Development Permit Panel

Wednesday, February 26, 2020
3:30 p.m.

1. **DEVELOPMENT PERMIT 18-825663**
(REDMS No. 6388360)

PROPERTY LOCATION: 2660 Smith Street

SHEET TITLE
RCP - MAIN FLOOR
PLAN

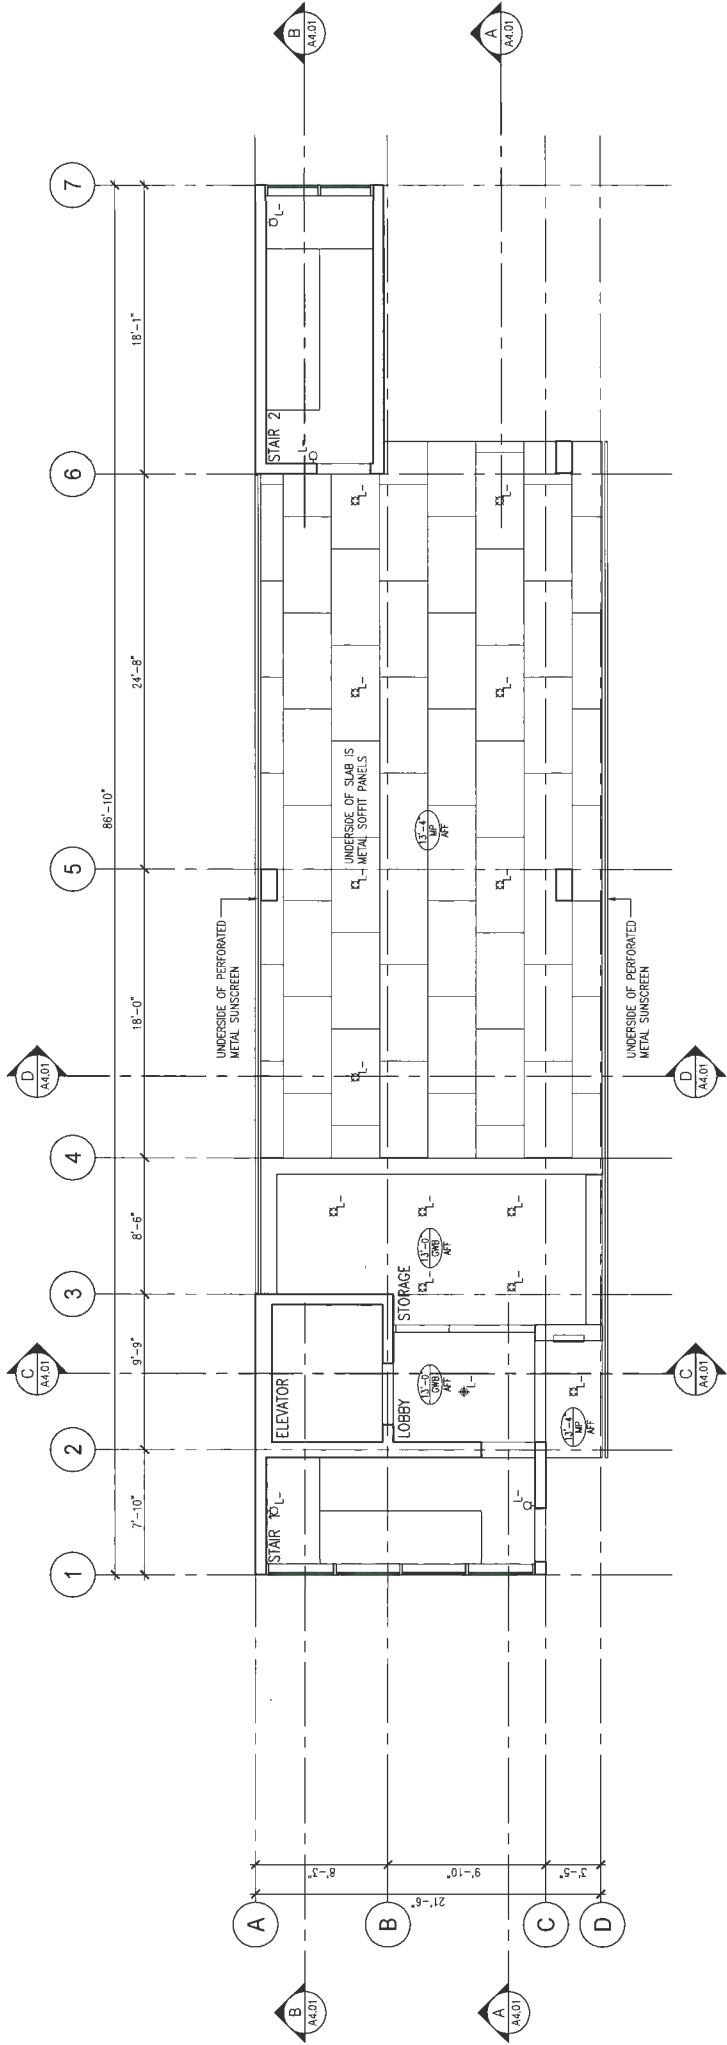
- identify the soffit material and provide a lighting plan due to the soffit's visibility from around the building;

Addressed. See drawing A2.40. Metal soffit panels to be used in the parking area. Lighting layout provided.

(iii) Addressed. See drawing A2.50. Lighting layout provided.

(iv) Addressed. See drawing A2.50. Metal soffit panels to be used in the parking area.

SHEET TITLE
ELEVATIONS
SOUTH AND WEST

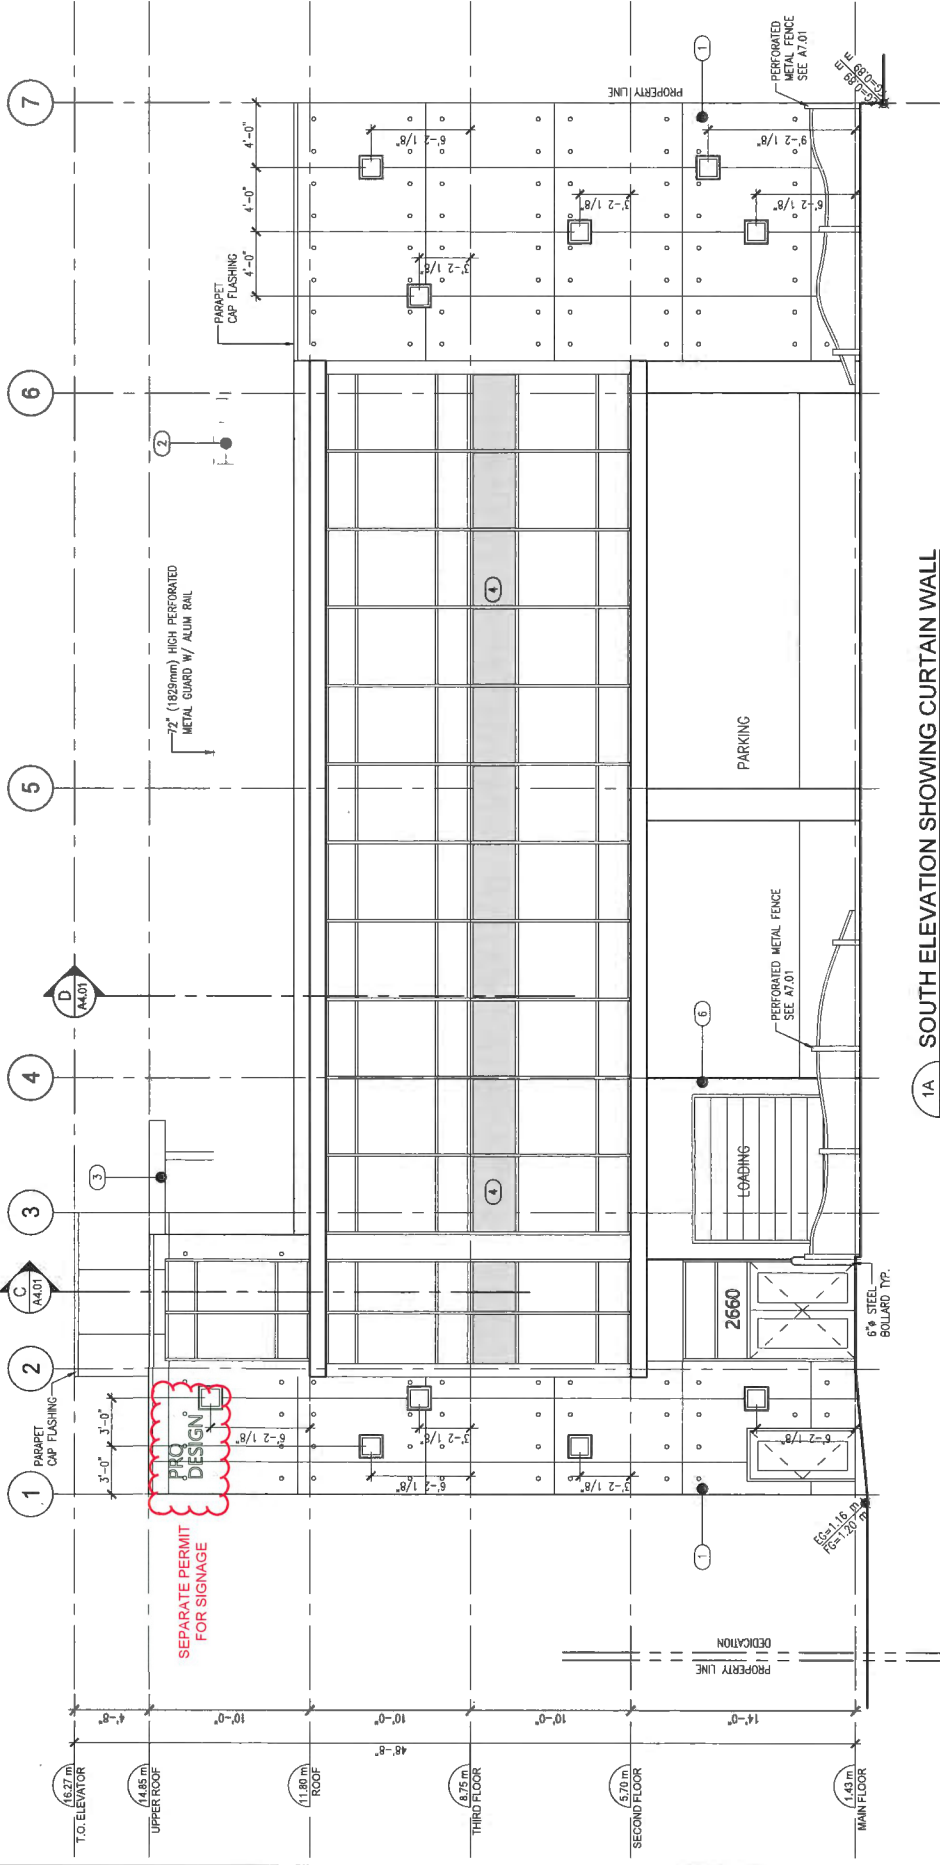
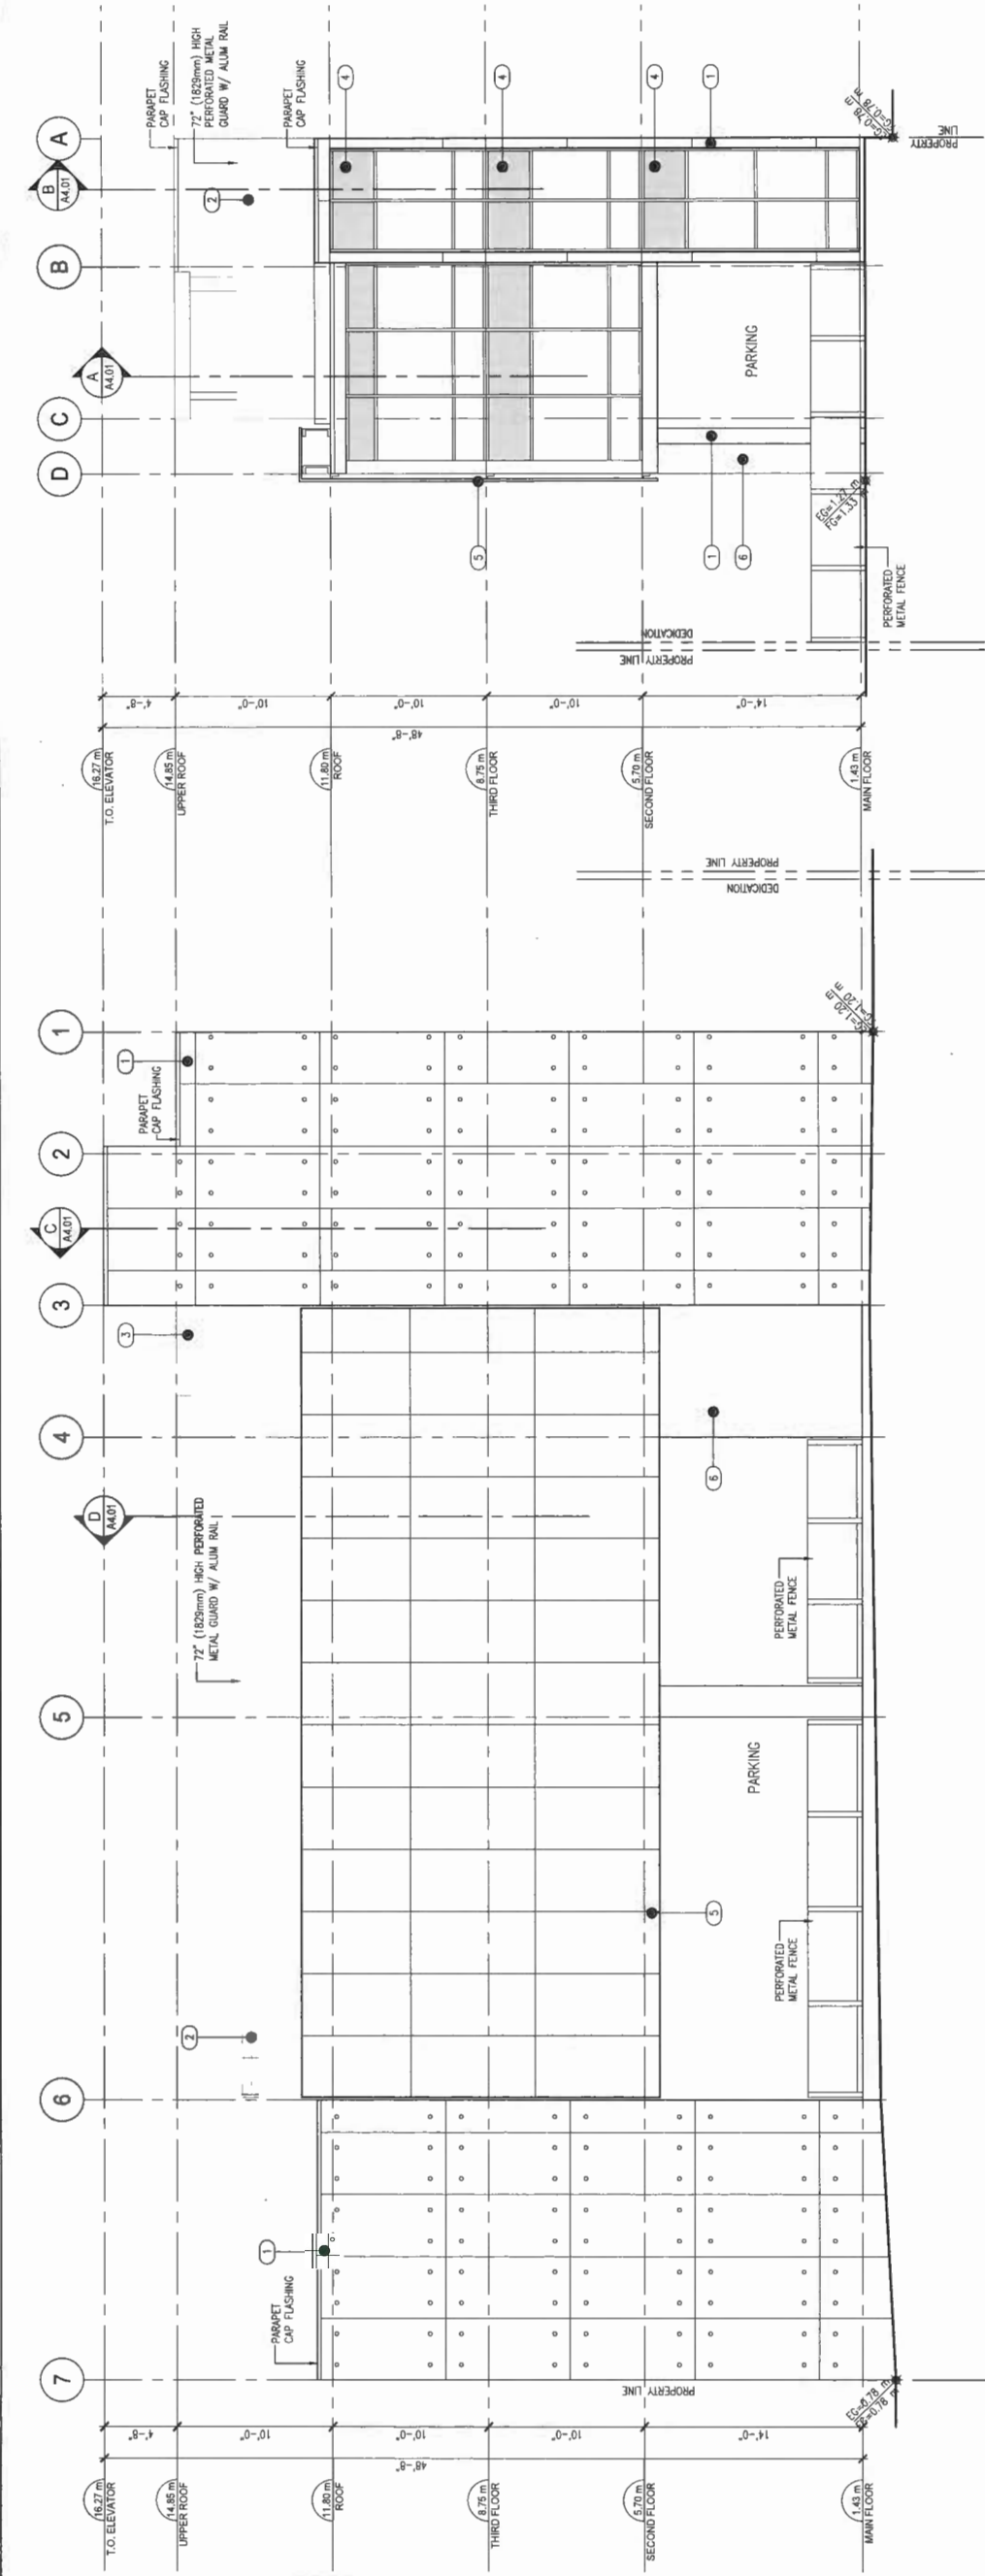
- appreciate the accessibility features of the project for people in wheelchairs;
- appreciate the perforated metal screen on the north face of the building to mitigate its blank wall appearance; the approach will help provide an appropriate interface until the adjacent property to the north is developed in the future; also consider integrating a pattern, e.g. score lines on the concrete portions of the wall, similar to the design elements on the south, east and west faces of the building to provide more visual interest and reduce the massing;

Addressed. See drawings A3.01 and A3.02. added architectural score lines to the concrete walls.

SKETCH TITLE
LANDSCAPE
DETAILS

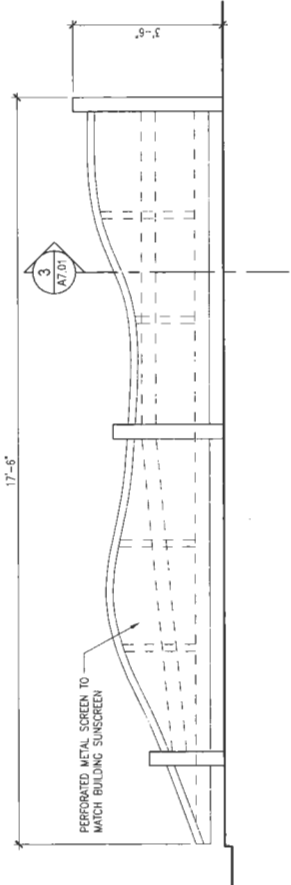
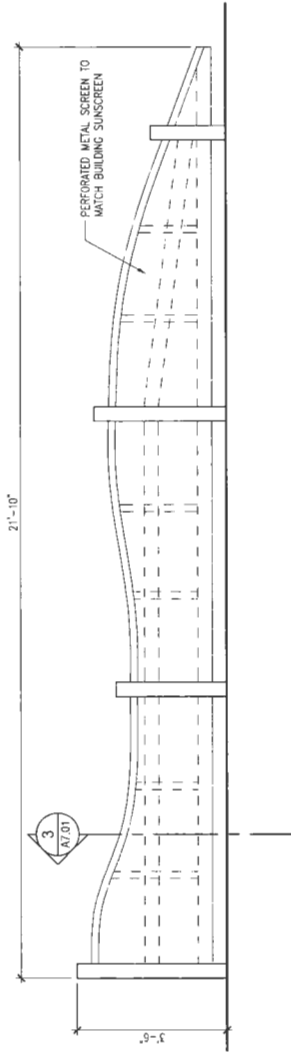
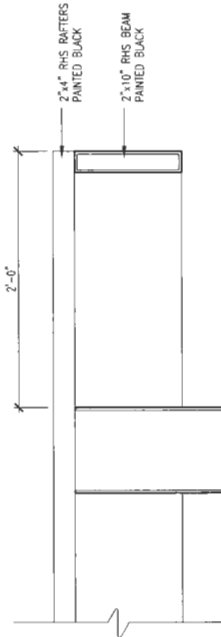
- the six-inch wide planting bed between the multi-use path and loading space will not work as it lacks the necessary size;

- the loading space separated from the multi-use path by a very narrow planting strip poses a safety issue for pedestrians; also consider installing a physical barrier between the loading space and the proposed pedestrian-oriented plaza for pedestrian safety; safety provisions on the ground level should also be considered for pedestrians coming out from the exit stairs, e.g. installing bollards or different paving treatment;

Addressed. See drawings A1.00, A2.10, and A7.01. Planting bed removed. Added perforated metal fence between multi-use path and loading space. Details provided.

Addressed. See drawings A1.00, A2.10, and A7.01. Added perforated metal fence between multi-use path and loading space. Light bollards proposed between loading space and entry plaza to provide physical barrier to pedestrian-oriented plaza. Details of perforated metal fence provided.

Addressed. See drawings A1.00, A2.10, and A7.01. Added perforated metal fence between multi-use path and loading space.

(ii) Addressed. See drawing A7.01. Details provided for fencing along the north and east property lines.
